UNITED STATES PATENT AND TRADEMARK OFFICE

| APPLICATION NO. | FILING DATE | FIRST NAMED INVENTOR | ATTORNEY DOCKET NO. | CONFIRMATION NO. |
|-----------------|-------------|----------------------|---------------------|------------------|
| 10/670,773 | 09/26/2003 | Bunsho Kuramori | 030712-13 | 4336 |

Office Action Summary

DETAILED ACTION

FIG. 2

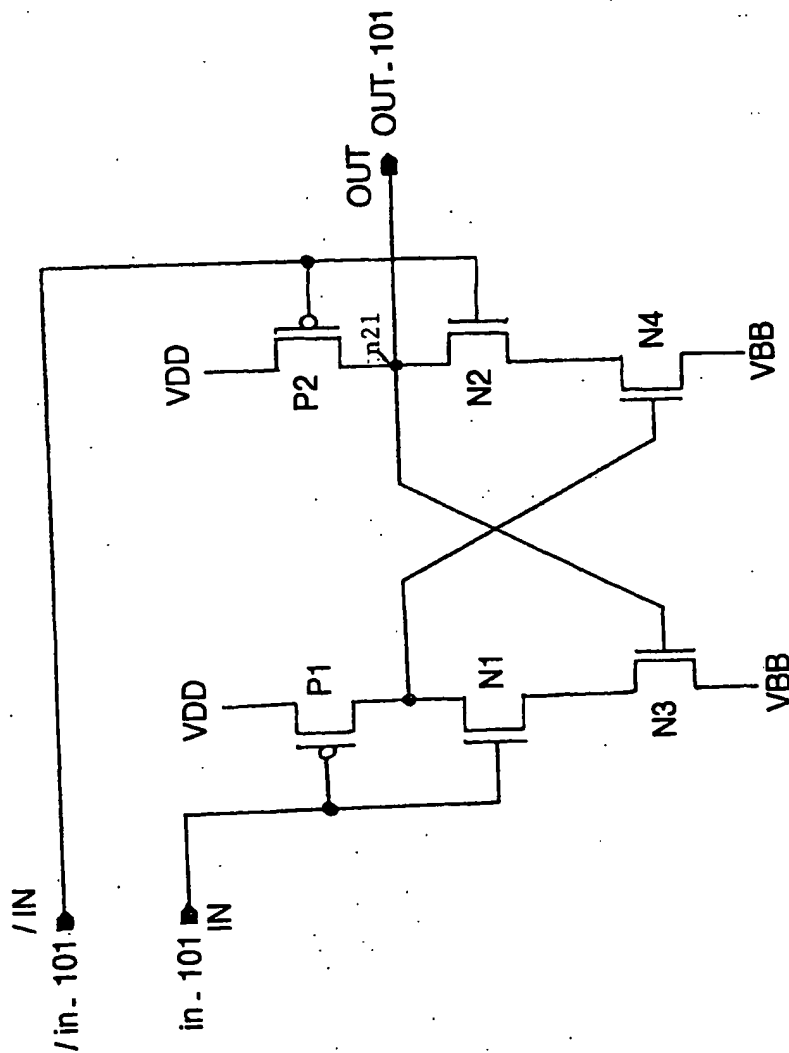
Approved
11.16.05
TLE
